PRODUCT UPDATE

Number: #121
By: D. Warren, Applications Engineering Dept.
Date: June 24, 2013

PCA.0E/PSA.0E Now with Anti-Rotation – PCP.0E becomes Obsolete

Details of Change:

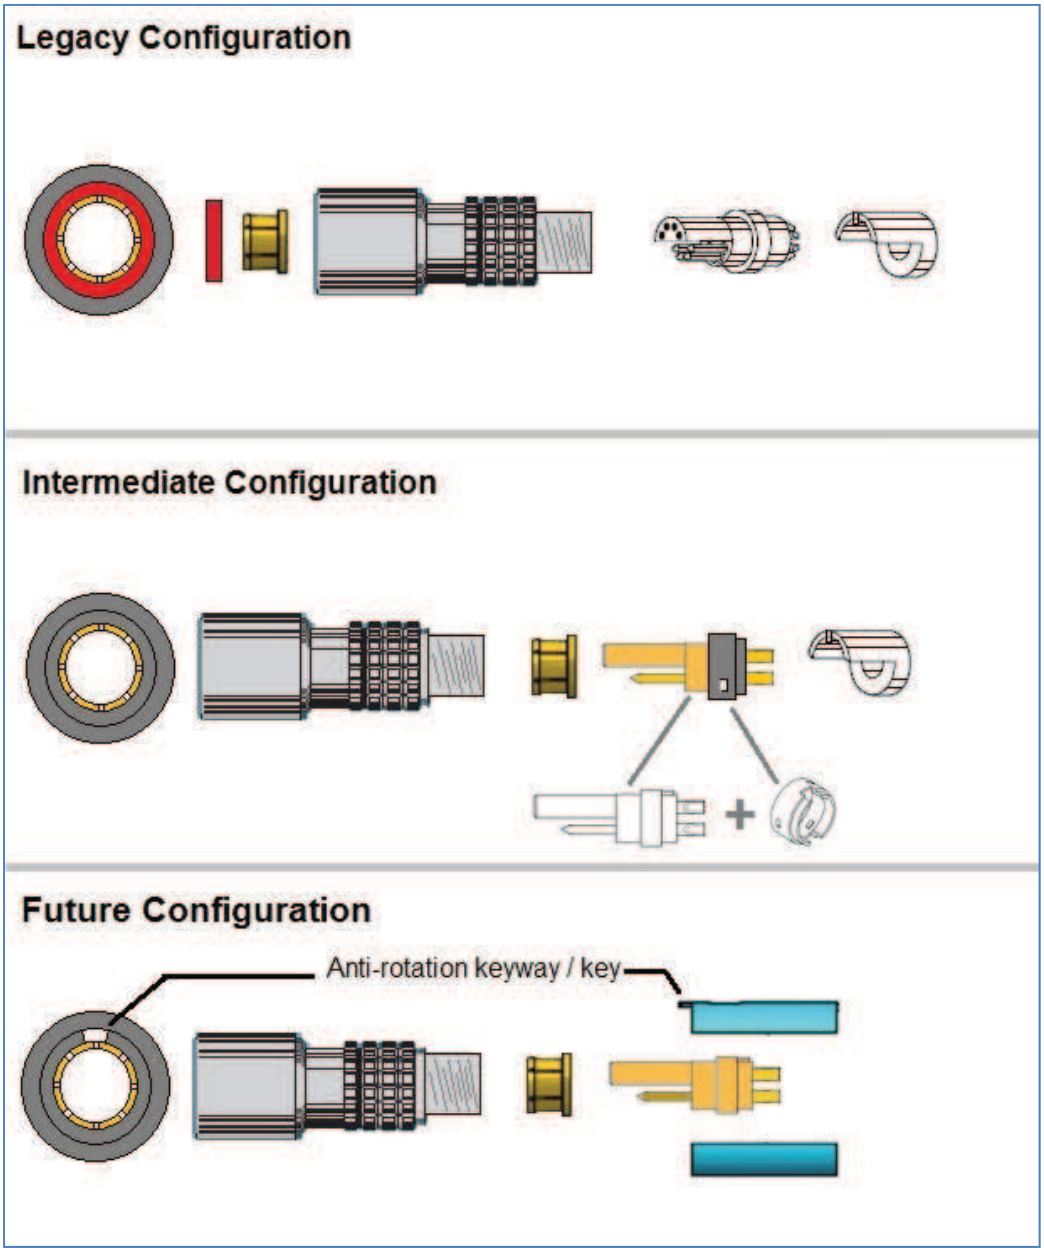
- The inner pieces of the **0E Series** will have a system of keyed components for enhanced anti-rotation characteristics. Anti-rotation models such as the PCP will be phased out and become standard with PCA and PSA models.

- There will be a keyway added to the inside of the receptacle. The new keyway will take advantage of the new inserts and keyed split mid-pieces which will have keys similar to the B Series. The collets will also have a keyway to align with the split mid-pieces.
